**METROPOLITAN GOVERNMENT OF NASHVILLE AND DAVIDSON COUNTY**

**STAFF RECOMMENDATION**  
**1915 Blair Boulevard**  
**August 17, 2016**

**Application:** New construction- addition; Partial demolition  
**District:** Belmont-Hillsboro Neighborhood Conservation Zoning Overlay  
**Council District:** 18  
**Map and Parcel Number:** 10416006400  
**Applicant:** Brittney Mount, Allard Ward Architects  
**Project Lead:** Melissa Sajid, melissa.sajid@nashville.gov

**Description of Project:** The request is to construct rear and side additions. The request also includes changes to windows on the left side of the historic house and those in the front dormer gable field.

# AS1.0

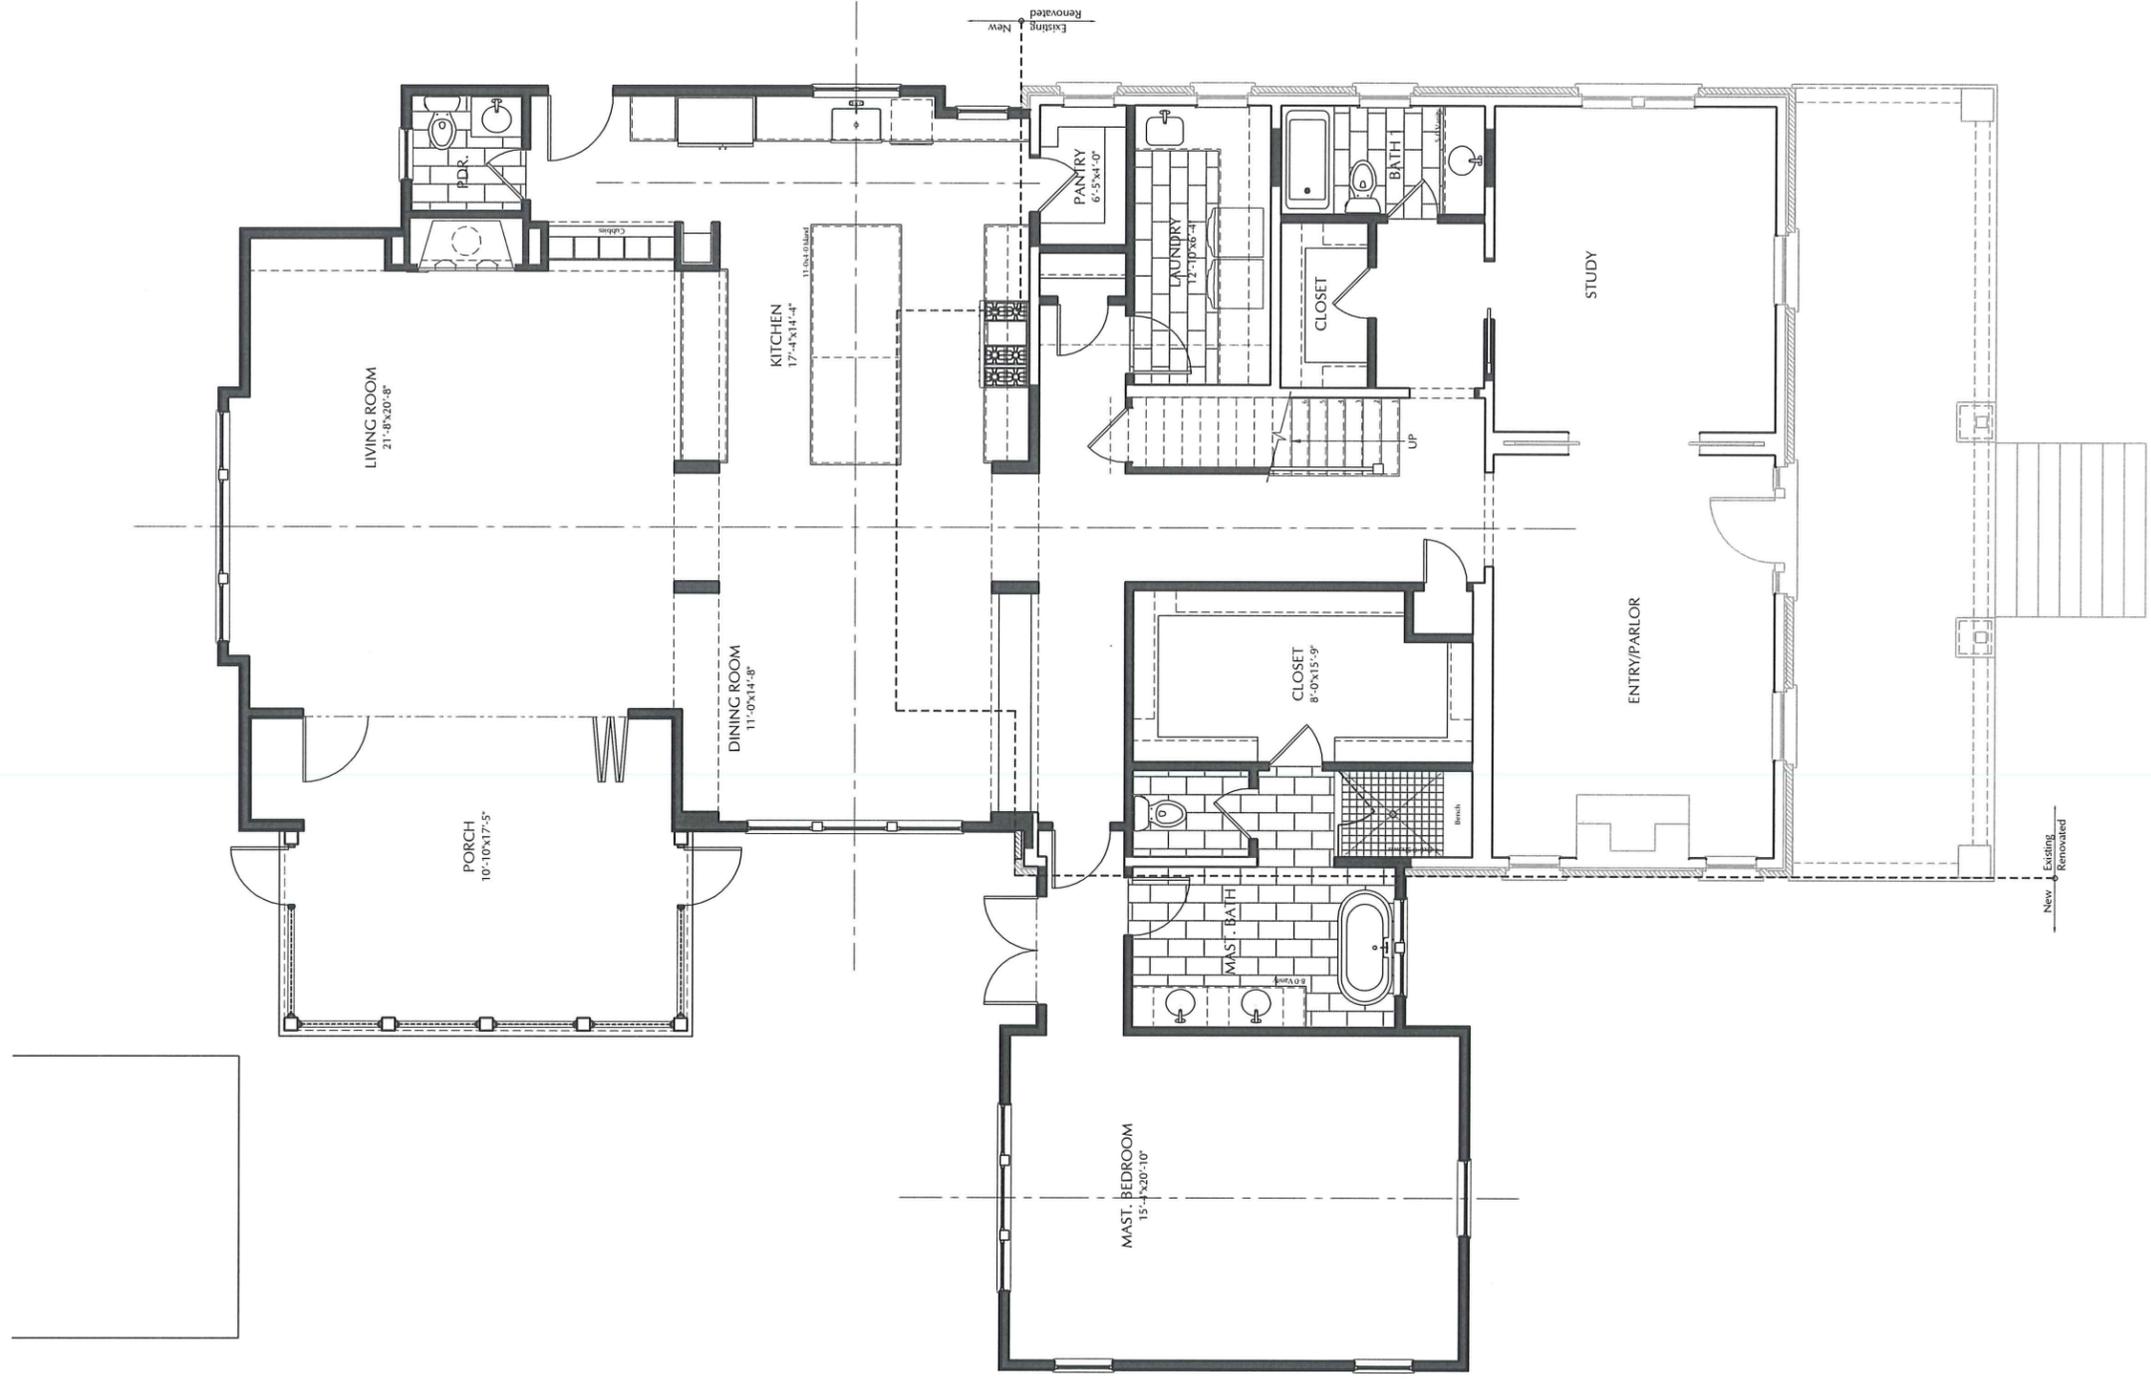
Setbacks: The new addition meets all setbacks required by the base zoning. The addition is located approximately forty-eight feet (48') from the rear property line, thirteen feet (13') from the right side property line, and six feet, ten inches (6'-10") from the left side property line.

Appurtenances & Utilities: No changes to the site’s appurtenances were indicated on the drawings. The location of the HVAC and other utilities was also not noted. Staff asks that the HVAC be located on the rear façade, or on a side façade beyond the midpoint of the house.

The lot is currently accessed via an existing curb cut and driveway from Blair Blvd, and the applicant proposes to continue using this access. While the side addition will cut off the existing driveway, it will still continue to approximately the midpoint of the house. Staff finds that this is appropriate as the curb cut and driveway are existing site conditions.

1. The driveway shall be shown on the site plan;
2. Staff approve the final details, dimensions, and materials of the roof color, windows, doors, porch floor, and porch steps prior to purchase and installation;  
and
3. Staff approve the masonry color, dimensions and texture.

**A2.0**

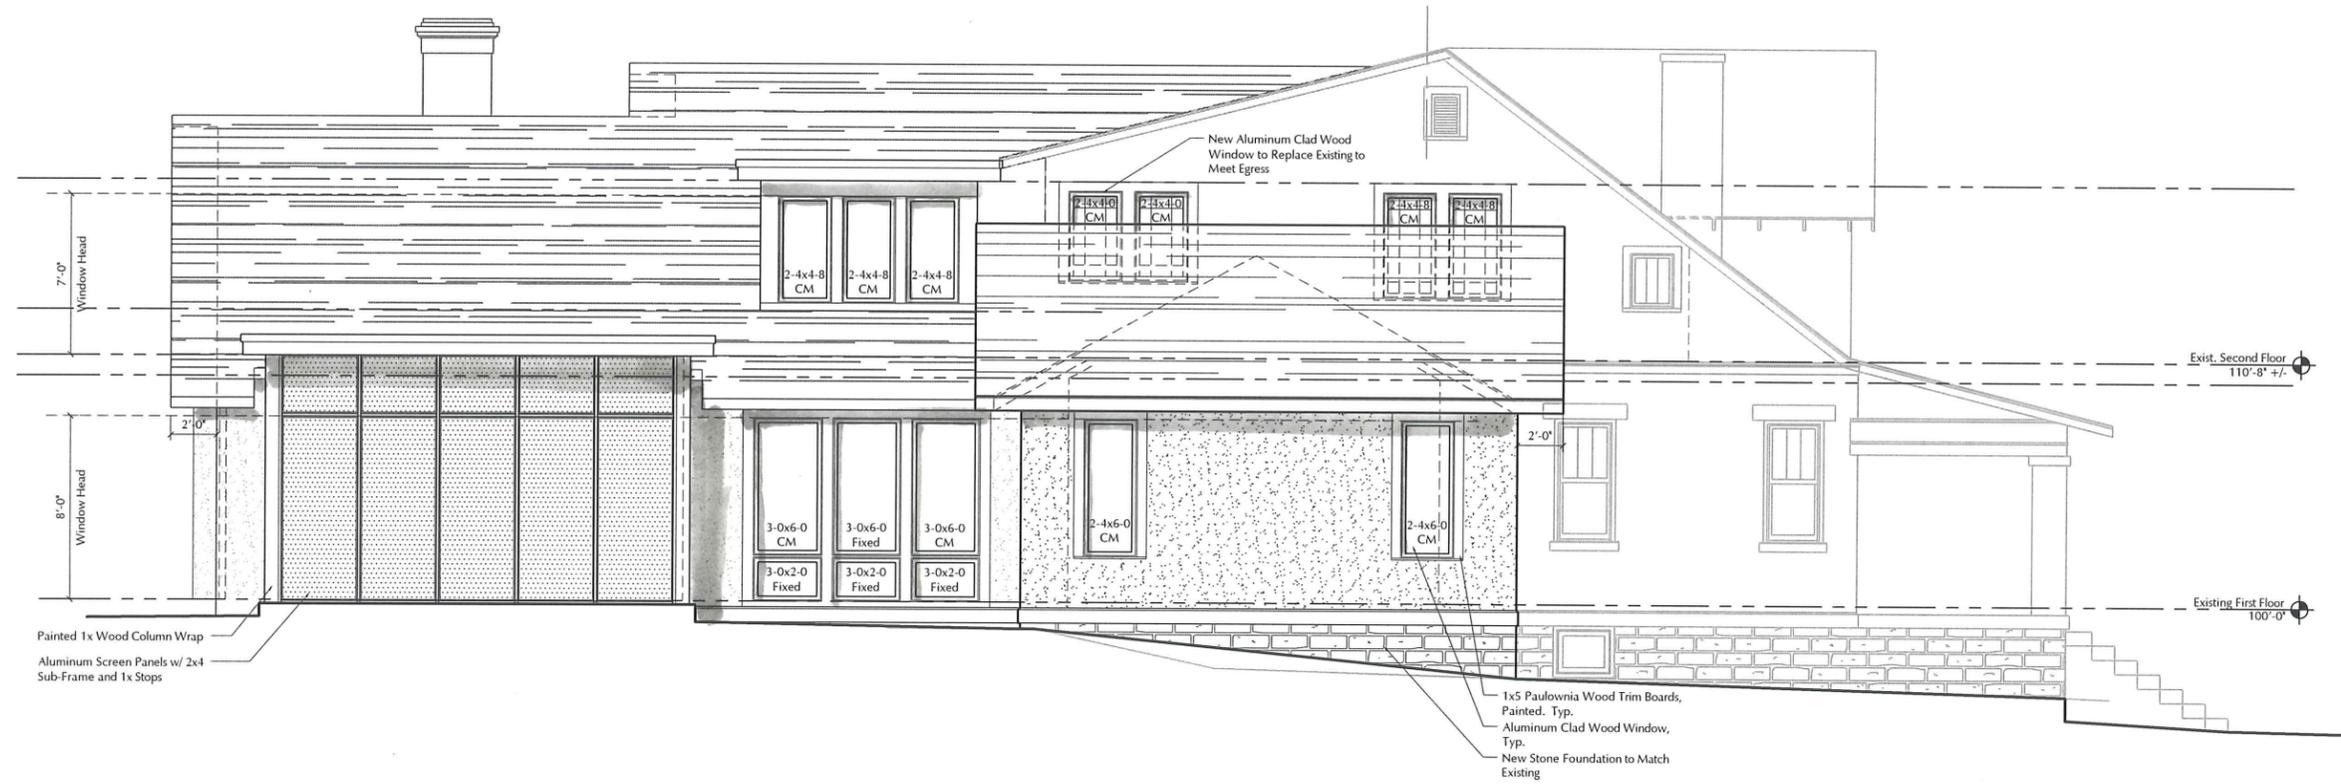
**Demolition:** The request includes altering the windows in the front dormer gable field to remove the mullion between the middle windows (Figure 2). The applicant has requested to alter the windows to meet egress requirements per the Fire Code as the interior will be a bedroom. The design guidelines prohibit alterations to the front façade of a contributing house unless the work is restoring a historic condition. In addition, 4”-6” mullions are a typical configuration of historic paired windows. In this case, however, staff finds that the alterations may be appropriate since the changes do not alter the size, number, or location of the windows, thereby changing the character of the historic house, two of the three mullions will remain, and the changes are proposed to meet current life safety standards of the Fire Code.

The rear addition has a maximum height that is approximately one foot (1') less than the ridge of the historic house. Eave height on the rear addition is similar to that of the historic house. The side addition has a maximum height that is eight feet (8') less than the ridge of the historic house and also has an eave height similar to that of the existing house.

**Roof form:** The roof form of the rear addition is a rear facing gable, with a 9:12 pitch that matches the historic house. The rear addition ties into the existing side-gabled roof one foot (1') below the ridge. The plan also incorporates a dormer on the left side of the rear addition; the dormer is shed-style and is inset from the side wall below by approximately two feet (2') as required for dormers.
